**Economic and Social Council**Distr.: General  
24 February 2023

**Economic Commission for Europe****Inland Transport Committee****World Forum for Harmonization of Vehicle Regulations****Working Party on Passive Safety****Seventy-third session**

**UN Regulation No. 17 (Strength of seats)****Proposal for the 11 Series of Amendments to UN Regulation No. 17 (Strength of seats) \*****Submitted by the expert from Germany**

Model A

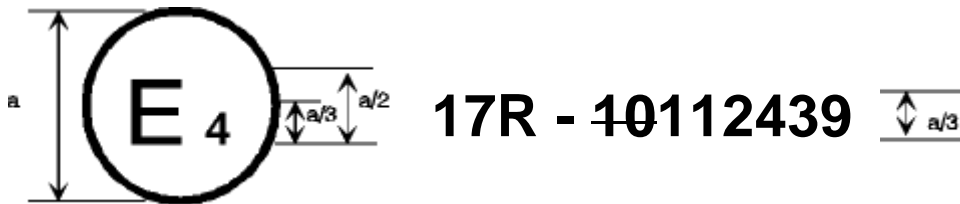
The above approval mark when affixed to a vehicle shows that the vehicle type concerned, with regard to the strength of the seats fitted or capable of being fitted with head restraints and with regard to characteristics of the head restraints, has been approved in the Netherlands (E 4) pursuant to UN Regulation No. 17, under the approval number ~~4011~~12439. The first two digits of the approval number indicate that the Regulation already contained the ~~4011~~ series of amendments at the time of approval. The above approval mark also shows that the vehicle type was approved pursuant to UN Regulation No. 17 with regard to the strength of any seats on the vehicle which are not fitted or capable of being fitted with head restraints.

Model C

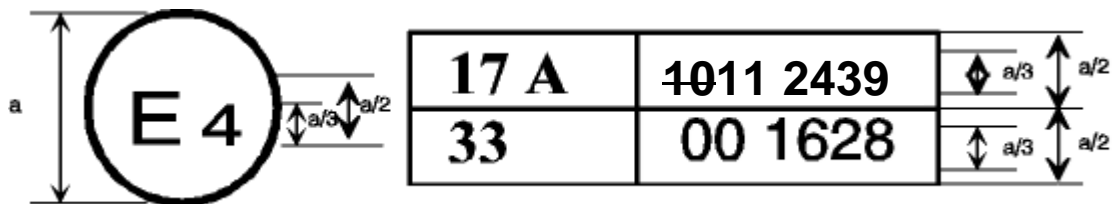
The approval numbers indicate that, on the dates when approval was granted, UN Regulation No. 17 included the ~~4011~~ series of amendments but UN Regulation No. 33 was still in its original form. The above approval mark also shows that the vehicle type was approved pursuant to UN Regulation No. 17 with regard to the strength of any seats on the vehicle which are not fitted or capable of being fitted with head restraints.

Model D

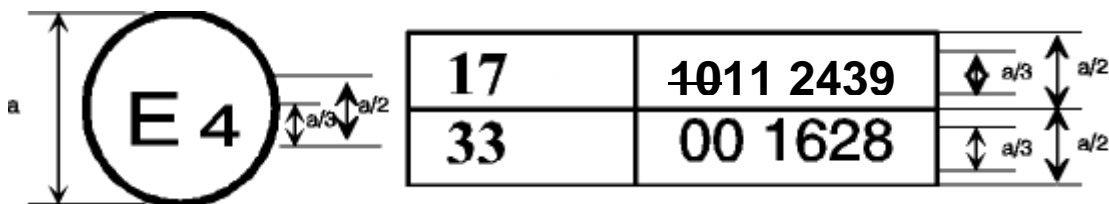
The above approval mark when affixed to a vehicle shows that the vehicle type has seats not fitted or capable of being fitted with head restraints, and was approved in the Netherlands (E 4) pursuant to UN Regulations Nos. 17 and 33.<sup>1</sup> The approval numbers indicate that, on the dates when approval was granted, UN Regulation No. 17 included the ~~40~~11 series of amendments but UN Regulation No. 33 was still in its original form.
